Product Change Notice (PCN)

PCN Number: **PCN-0450019R-01**

Product(s) Affected: **PJ-071**

Description of Change: **Material Change. New PCB Dimensions included (pad sizes)**

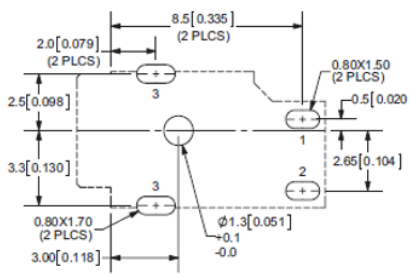
Reason(s) for Change: **Manufacturing Improvement processes**

MATERIAL	PLATING																																			
center pin	brass	tin																																			
terminal 1	brass	tin																																			
terminal 2	copper alloy	tin																																			
terminal 3	copper alloy	tin																																			
plastic	PAB6																																				
DESCRIPTION	MATERIAL	PLATING/COLOR																																			
center pin	brass	tin																																			
terminal 1	brass	tin																																			
terminal 2	copper alloy	tin																																			
terminal 3	brass	tin																																			
housing	PBT (UL94V-0)	black
